REQUEST FOR INFORMATION AND EXPRESSION OF INTEREST (RFI)
for
MATERIALS FOR BROADBAND NETWORK

Questions and answers
V2_7.6.2023

June 2023

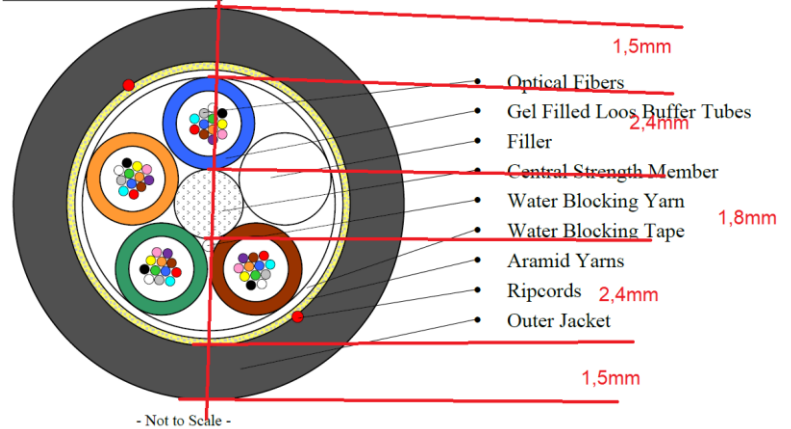
Q11: Questions to: 05_Appendix 5_Technical requirements for cables

- ADSS 50 m 12-48 - spec says that in case of 12 and 24F the outer diameter (OD) should be 7mm and in case of 48F 10mm. However 12-48F is the same construction what is indicated by required FRP and Tube size. Therefore "12-48F ADSS 50m span" would all be 10 mm?

In other words, please confirm, that the outer diameter should be 10mm, not 7mm as described in specification.

A11: Confirmed, outer diameter of cable 12-48F can be 10mm.
